P&Z CASE # SP2019-050 P&Z DATE 12/30/19 CC DATE _____ APPROVED/DENIED

TO: Planning and Zoning Commission
DATE: January 14, 2020
APPLICANT: Ross Ramsay; *Ramsay & Reyes, LLC*
CASE NUMBER: SP2019-050; *Site Plan for Lot 17 & 17-1, Rainbow Acres Addition*

SUBJECT: SP2019-050; *Site Plan for Lot 17 & 17-1, Rainbow Acres Addition*

**LANDSCAPE PLAN –
PROPOSED BUILDING**
SCALE: 1"=40'

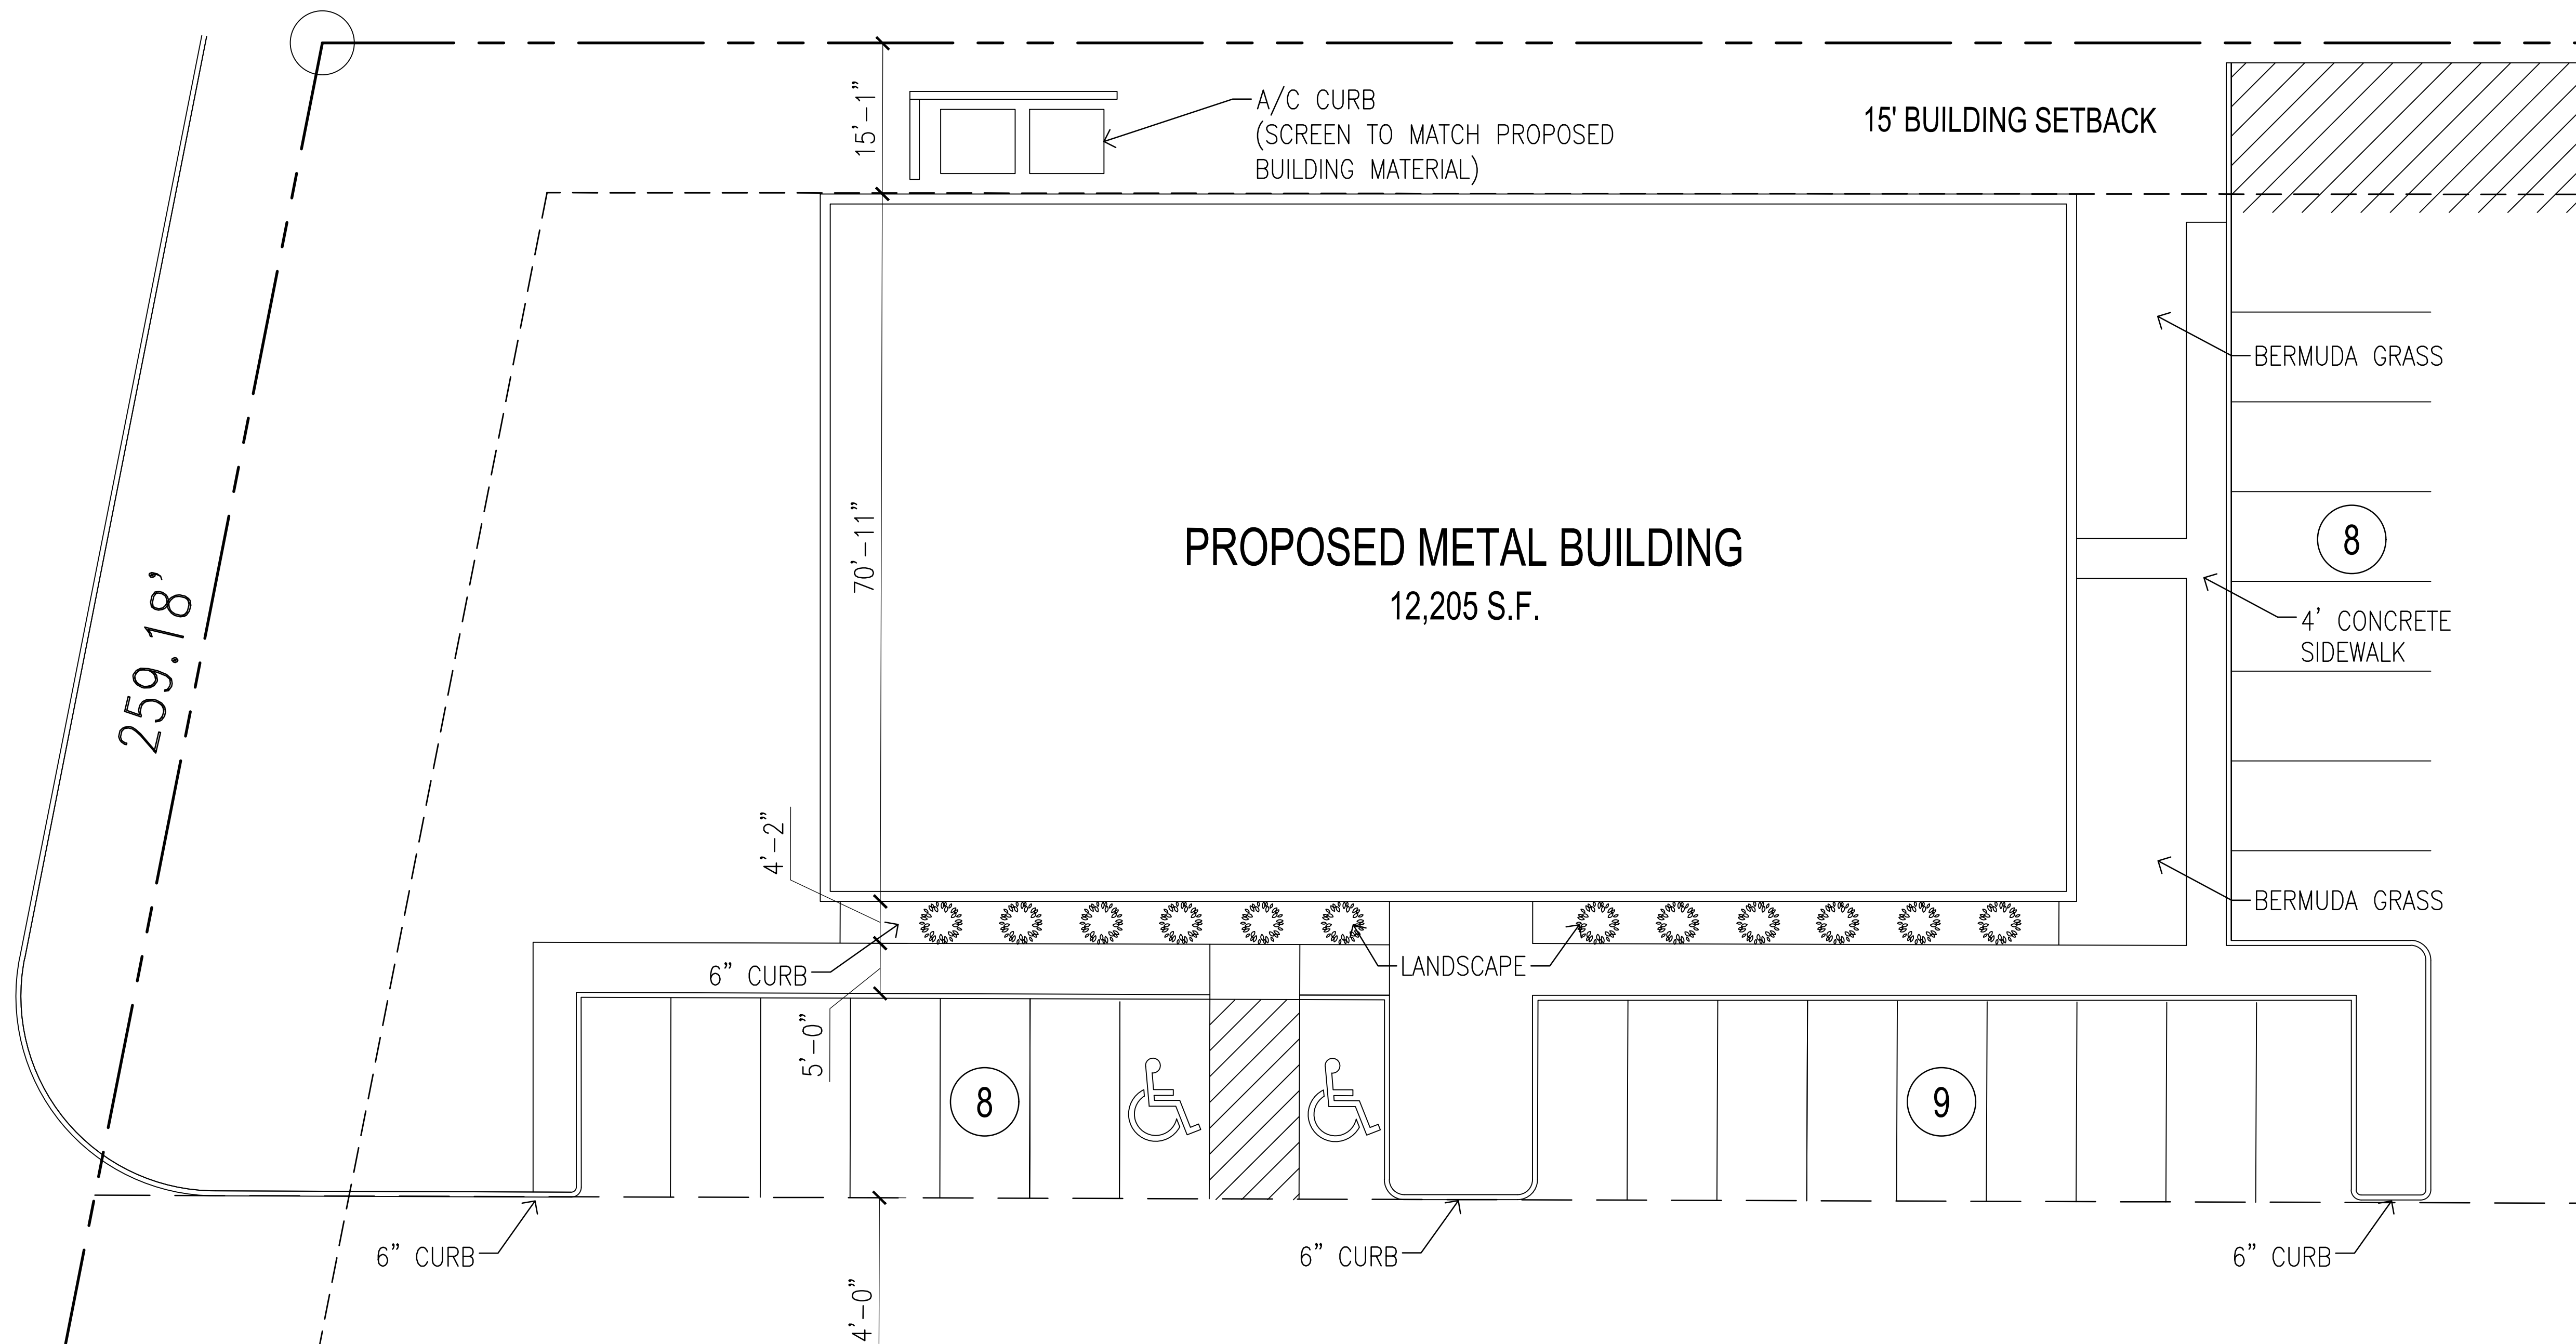
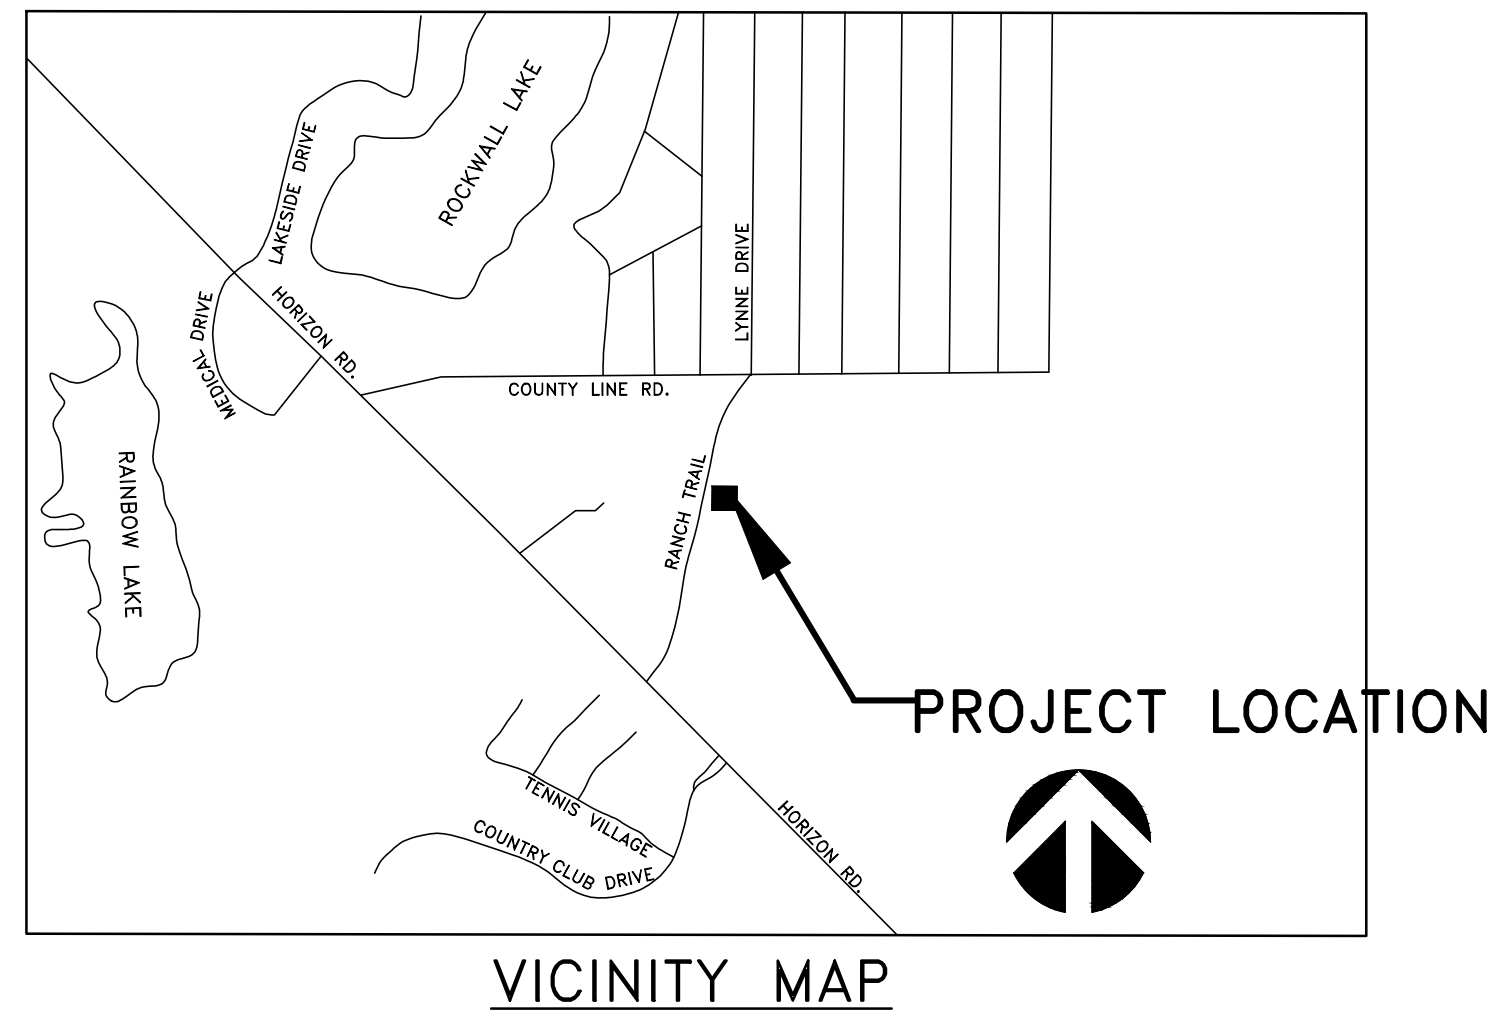
(1) Landscape Plan.

- A. Indicate the locations of all existing and proposed landscaping (including trees along Ranch Trail). (*Section 3, Art. VIII, UDC*)
- B. Under the plant schedule, indicate the minimum height of four (4)-feet for the 12 Texas Sage accent trees to be planted. (*Section 4(A)(2), Art. VIII, UDC*)
